Crane Division, Naval Surface Warfare Center submits the Draft Statement of Basis for the Dye Burial Grounds (DBG), Solid Waste Management Unit 2. One copy is provided for review and comment as enclosure (1). The permit required Certification Statement is provided as enclosure (2).

RESPONSE TO NAVY COMMENTS (DATED AUGUST 29, 2005) ON THE INTERNAL DRAFT VERSION OF: UNITED STATES ENVIRONMENTAL PROTECTION AGENCY STATEMENT OF BASIS FOR CORRECTIVE ACTION AT SOLID WASTE MANAGEMENT UNIT #02/11 (DYE BURIAL GROUNDS), NAVAL SURFACE WARFARE CENTER CRANE, CRANE, INDIANA

United States Environmental Protection Agency Statement of Basis For Corrective Action At Solid Waste Management Unit #02/11 (Dye Burial Grounds) Naval Surface Warfare Center Crane, Crane, Indiana

Figure 4: DBG Boundary and Trenches

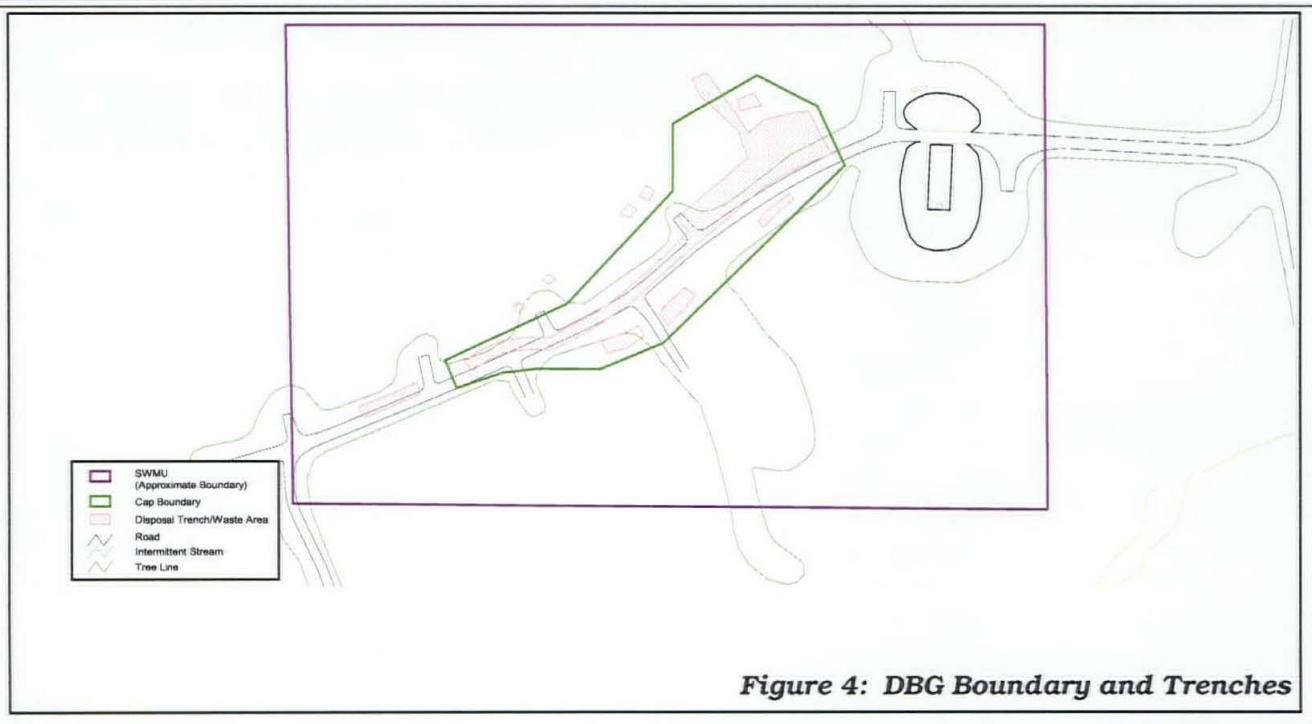
Figure 4 callout and Figure 4: Figure 4 does not really add anything to this bullet. Consider using another figure.

Agreed. The callout to Figure 4, which is intended to show the relationship of the cap to the burial trenches, has been moved. The callout now appears in a new sentence added at the end of the paragraph in which Figure 3 is called out. The new sentence is as follows:

"Figure 4 depicts the burial trench locations relative to the approximately 4.2-acre capped area."

In addition, the original Figure 4 callout on page 7 has been deleted. No new figures have been added.
